深圳市鑫扬泽电子有限公司

SCALE:	N/A	UNIT	mm	THE UNMARKED TOLERANCE ARE AS BELOW :				DESIGNED BY:		DWG. NO.	YZP0332-17075-01
SHEET:	1 of 1	PROJECTION		LENGTH		ANGLE		CHECKED BY:		TITLE:	Pogo pin 连接器
DATE:	2020.08.17	VER.	A.1	X.XX	$\pm 0.05\text{mm}$	X.XX	$\pm 0.50^{\circ}$	APPROVED BY:			
				X.X	$\pm 0.10\text{mm}$	X.X	$\pm 1.00^{\circ}$				
				X.	$\pm 0.20\text{mm}$	X.	$\pm 2.00^{\circ}$

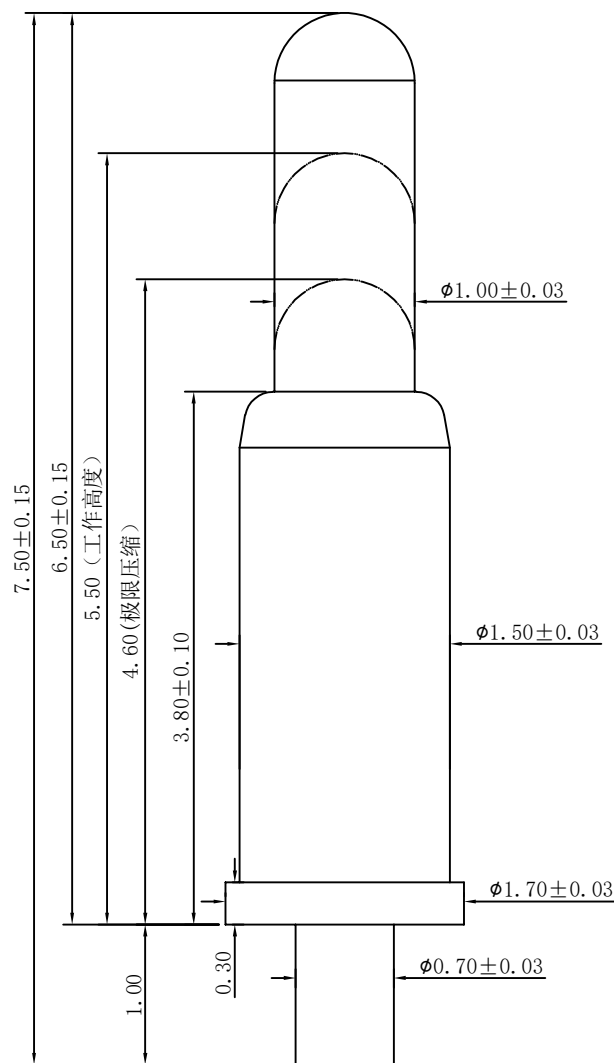
NO.	ECN NO.	DESCRIPTION	DATE
1	A.1	A. 1-6. 8±0.15改为6. 5±0.15	2020. 8. 10
2	A.1	A. 1-5. 8工作高度变为5. 5	2020. 8. 10
